# Memo

**To:** Patricia Davis, P.E., Brad Marshall  
**From:** Jonathan Tran, P.E., Ron Mick, P.E.  
**Copy:** Matt Gaughan, P.E., Charles Cameron  
**Date:** November 12, 2021  
**Subject:** CWWTP1 Change Order 0005

For the Central Wastewater Treatment Plant Expansion project, the Owner's Representative Team recommends approval of the attached Change Order 0005 in the amount of \$125,009.25 and 113 additional days to the contract with BAR Constructors, Inc. as indicated in Table 1 below.

**CMU WALL LAYOUT AND REINFORCING PLAN**  
 1/4"=1'-0"

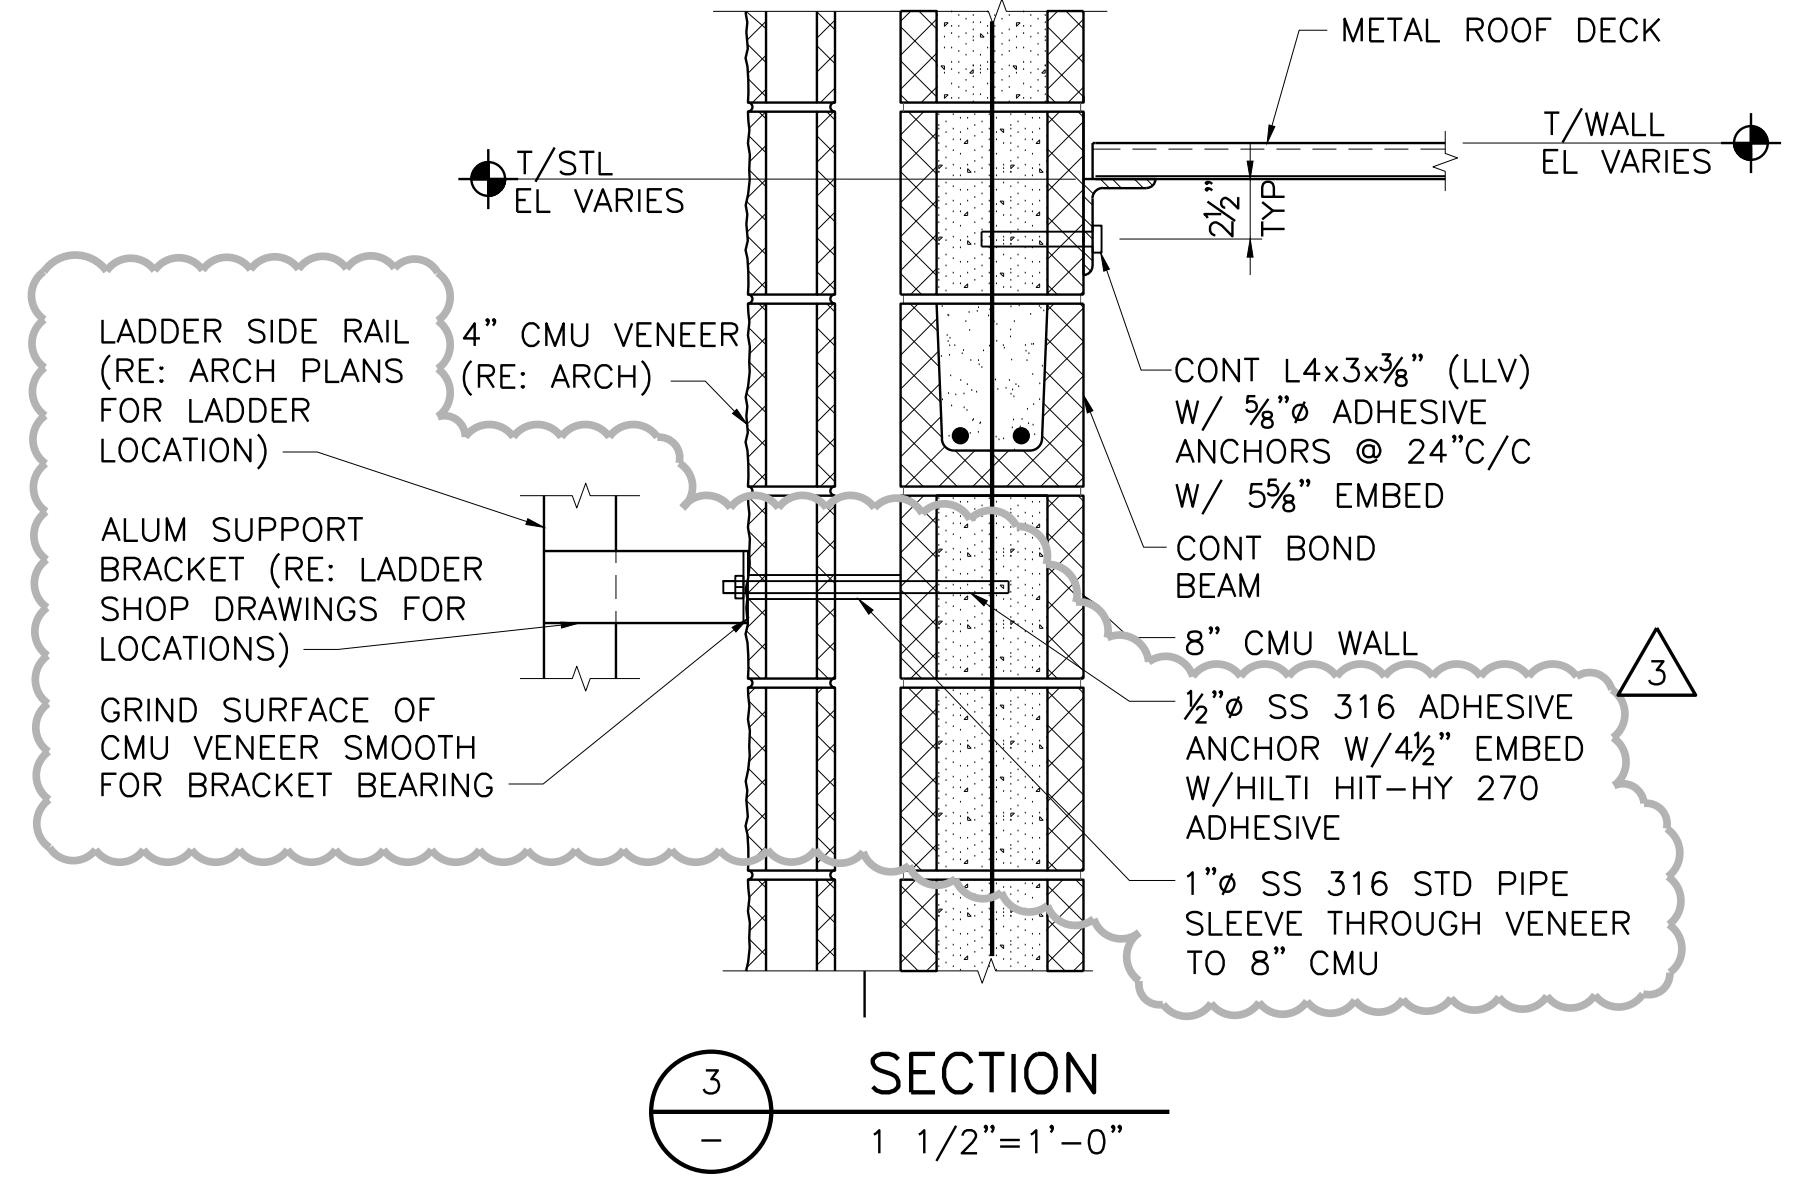
Replace sheet **S-EB-2 Electrical Building No. 1 Framing and CMU Wall Layout Plans** with the revised version attached to this field order. The modification to this sheet clarifies the means of attaching the roof ladders to the side of the electrical buildings via anchoring into the 8" CMU wall.

<b>Purpose of Change Proposal:</b>			
The Structural Engineer issued a revised ladder anchor attachment detail on 6/29/21 that provides a more structurally secure ladder. Revision to the ladder at EB-3 will be required and additional hardware will be required at EB-1 and 2.			
<b>Attachments:</b>			
<b>Requested Action:</b>			
<input type="checkbox"/> Issue a Field Order <input checked="" type="checkbox"/> Issue a Work Change Directive or Change Order for the described changes			
<b>Basis of Compensation:</b>			
<input type="checkbox"/> Unit Prices <input checked="" type="checkbox"/> Lump Sum calculated using Cost of Work provisions in General Conditions Paragraph 13.01 <input type="checkbox"/> Time and Materials using Cost of Work provisions in General Conditions Paragraph 13.01			
<b>Required Documentation:</b>			
<input checked="" type="checkbox"/> Detailed cost breakdown attached showing labor, materials, equipment, and all other costs for this change <input type="checkbox"/> Schedule attached to show impacts and justification for requested change in Contract Times

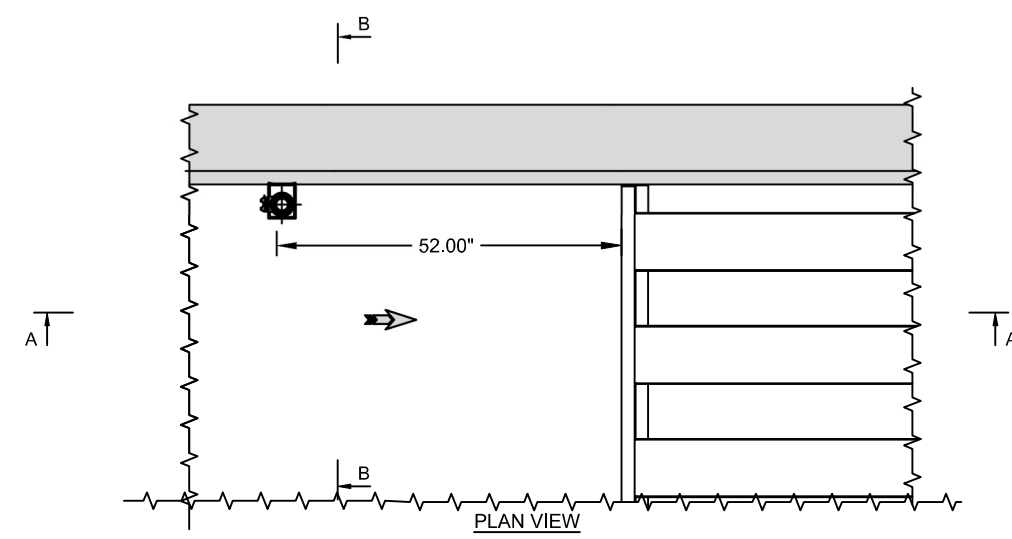
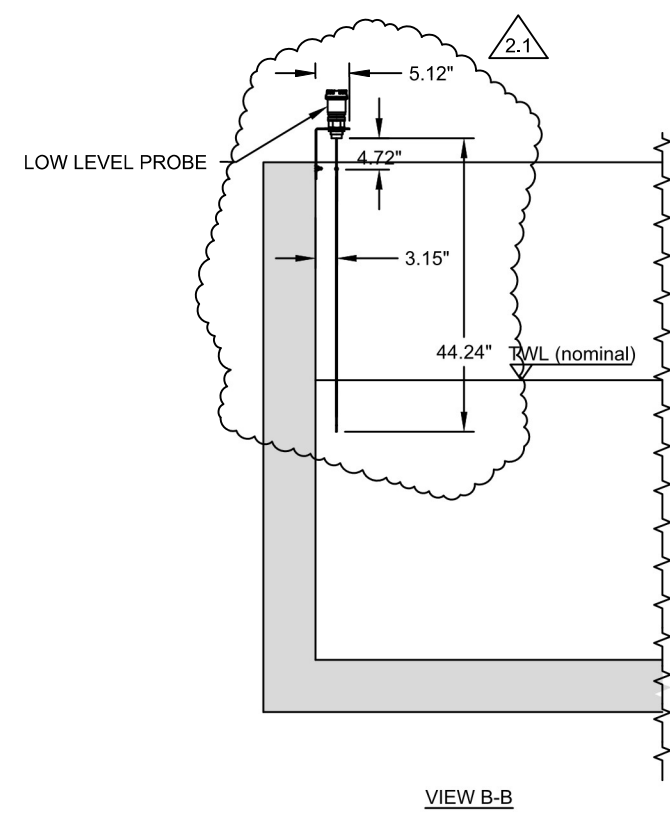
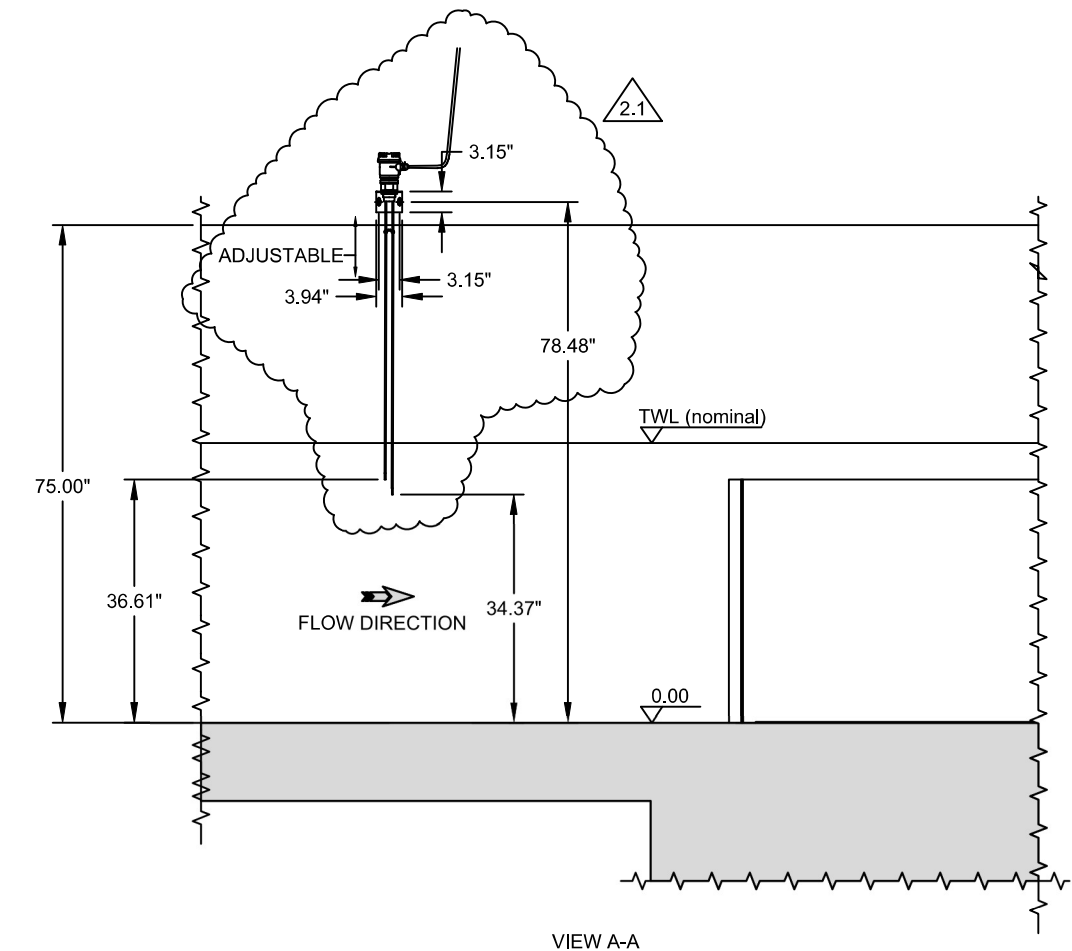
Xylem will provide (2) new E&H FTW Liquipint conductivity level probes. The probe length will be 59.10" in order to be installed as per the attached drawing. The connection point to the existing bracket will be 1 1/2" NPT.
